Project	<b>IEEE 802.16 Broadband Wireless Access Working Group</b> < <a href="http://ieee802.org/16">http://ieee802.org/16</a> >	
Title	<b>Clarification of renumbering and permutation based on DL_PermBase parameter</b>	
Date Submitted	<b>2005-05-05</b>	
Source(s)	Sean Cai Jason Hou Lijun Hu  ZTE San Diego Inc. 10105 Pacific Heights Blvd. San Diego, CA 92121 USA  Lei Wang  Cygnus Multimedia Communications, Inc.  Yigal Leiba Yossi Segal Runcom Ltd.	<a href="mailto:scai@ztesandiego.com">scai@ztesandiego.com</a> <a href="mailto:jhou@ztesandiego.com">jhou@ztesandiego.com</a>  Voice: 858-554-0387 Fax: 858-554-0894  <a href="mailto:lwang@cygnuscom.com">lwang@cygnuscom.com</a> Voice (760)448-1984 Fax: (760)448-1989  <a href="mailto:yigall@runcom.co.il">yigall@runcom.co.il</a> Voice:+972-3-9528440 Fax:+972-3-9528805
Re:	IEEE 802.16 WG Recirculation Ballot #17a on P802.16-2004/Cor1/D2	
Abstract	This contribution is for clarification of renumbering and permutation based on DL_PermBase parameter

# Clarification of renumbering and permutation based on DL\_PermBase parameter

Figure 219-Illustration of OFDMA frame with multiple zones

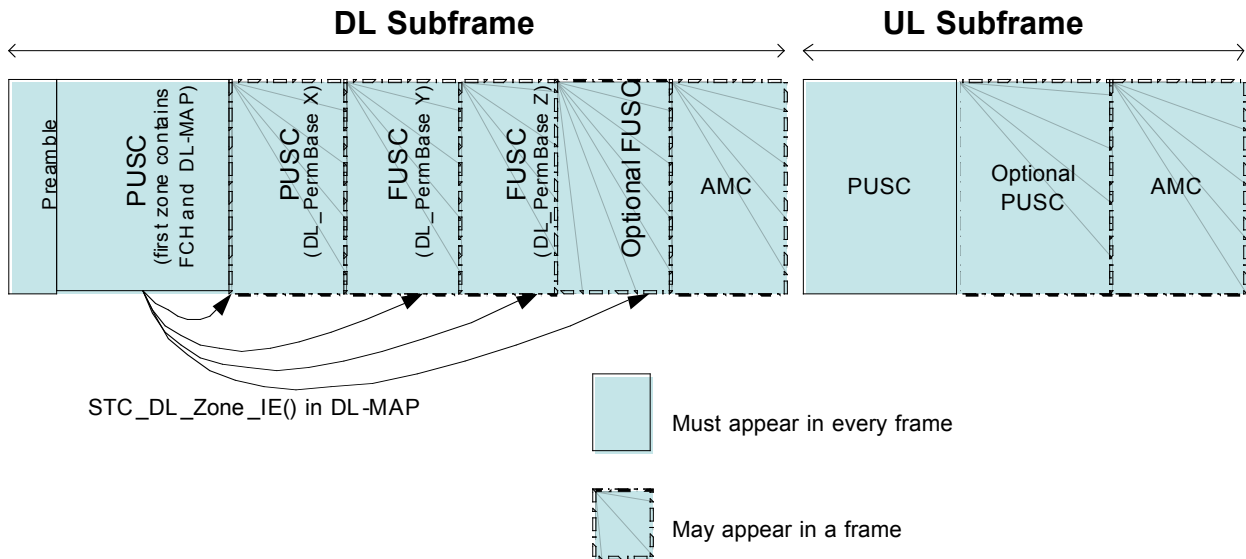
[Replace Figure 219 with the following figure:]
